GILDA PUENTE-PETERS
ARCHITECTS

POLICE STATION
ACCESSIBILITY SURVEY

July, 2007

CITY OF SANTA
BARBARA

Site - Photo # 3

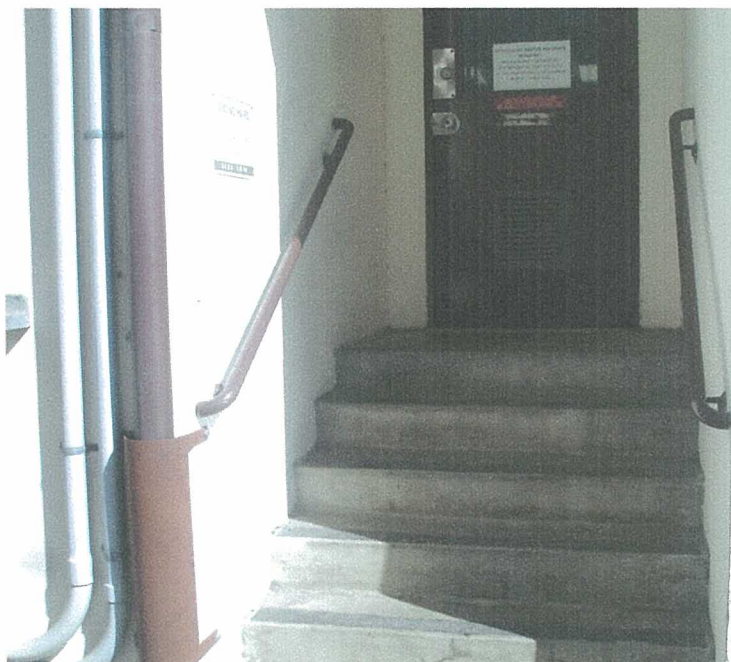
Intermediate handrail does not have top and bottom extensions. No handrail provided at both sides of stairs.

Building - Photo # 2

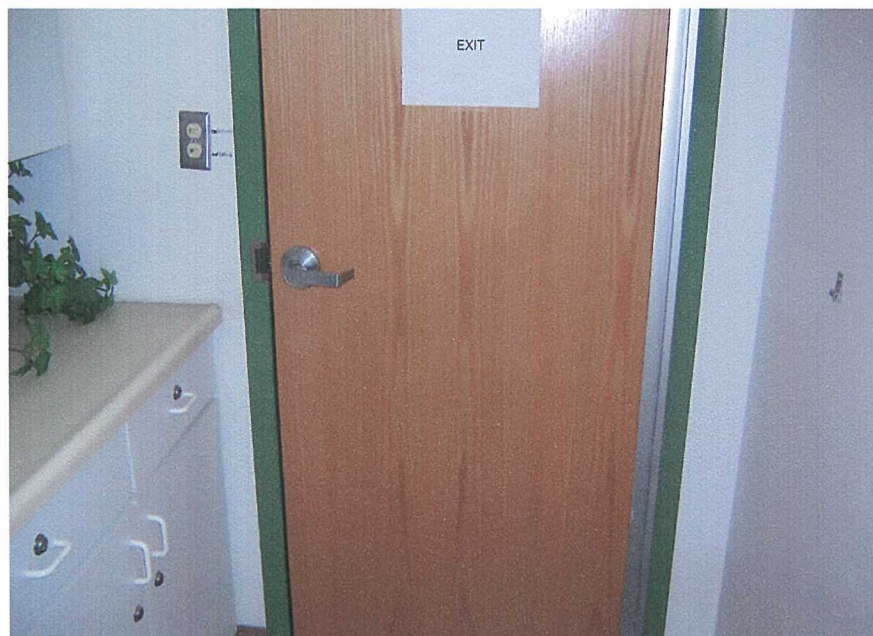
Pas-thru mounted at 44" high counter instead of 34" maximum. Handle mounted at 51" high instead of 48" high maximum.

Building - Photo # 5

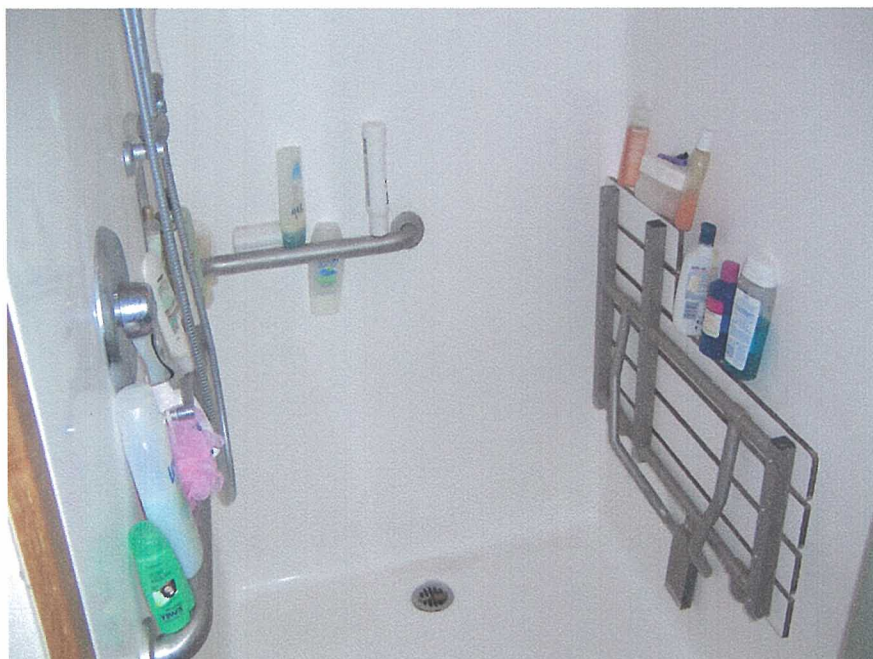
Gate clear width to holding cell is 22 ½" wide instead of the required minimum 32" wide.

Building - Photo # 13

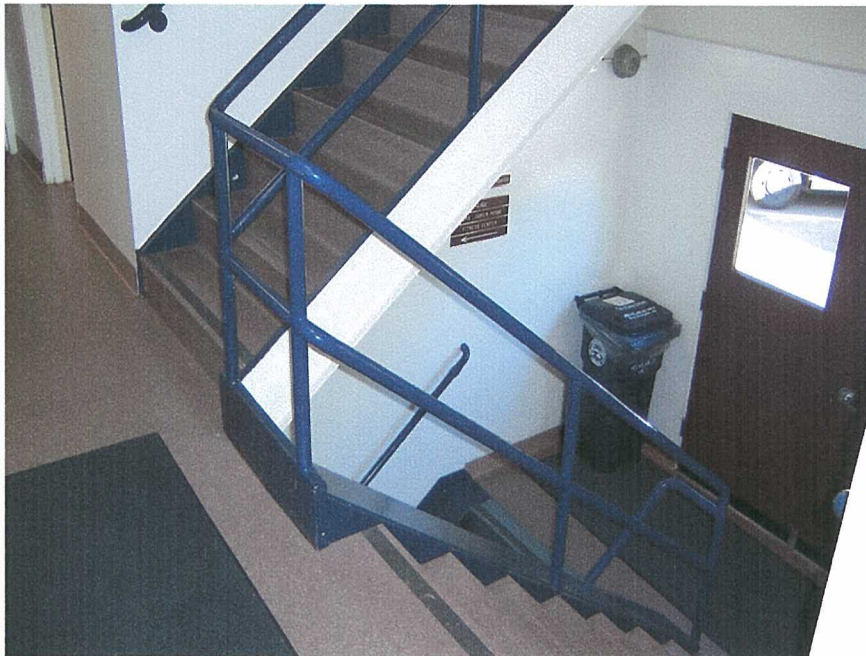
Sink is mounted 16" from the wall to the centerline of fixture, soap and paper towel dispensers are mounted too high. Trashcan blocks the required maneuverable clearance in front of sink. Paper towel dispenser protrudes 9 1/2" from the wall at 53" high becoming a protruding object without a cane detectable warning element.

Building - Photo # 1

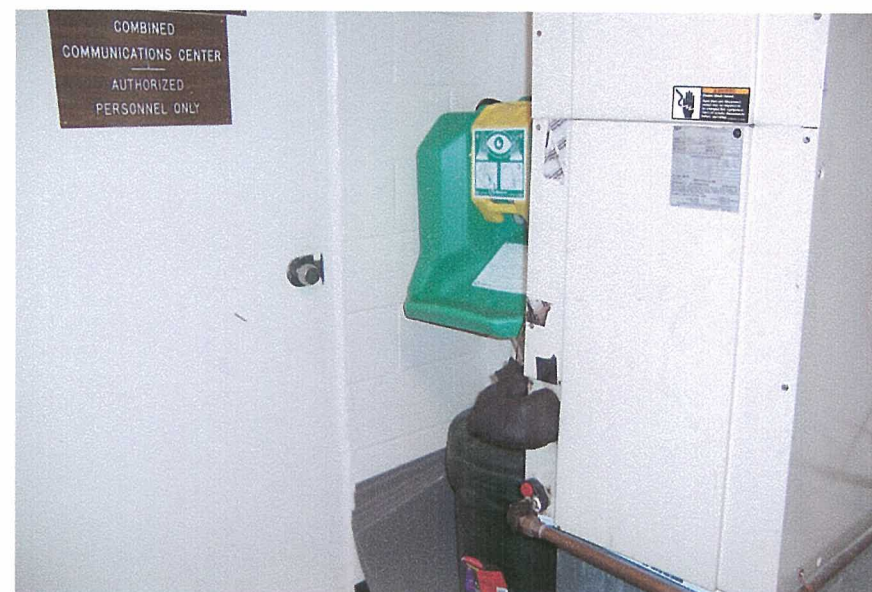
Kitchenette sink does not have the required knee clearance, counter is 36" high instead of the maximum 34" high.

Building - Photo # 2

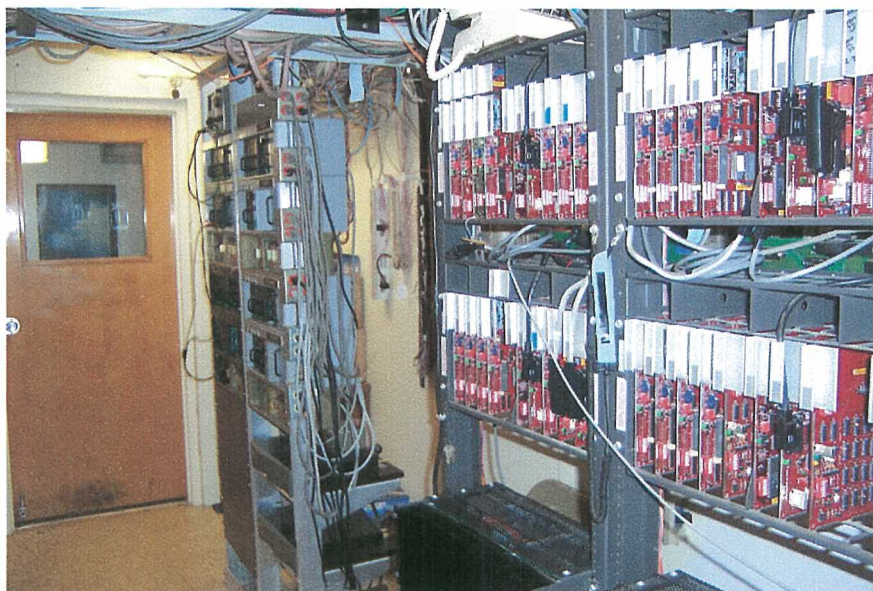
Emergency eyewash is not accessible, without the required knee clearance and wheelchair maneuverable space.

Building - Photo # 3

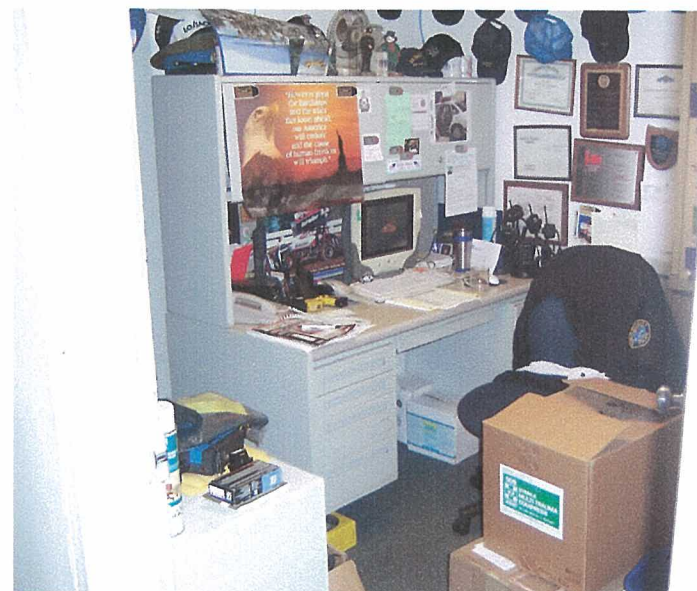
Door has knob instead of lever hardware or other type of accessible hardware. Doorstop is mounted at the lower kick-plate area on the push side of the door.
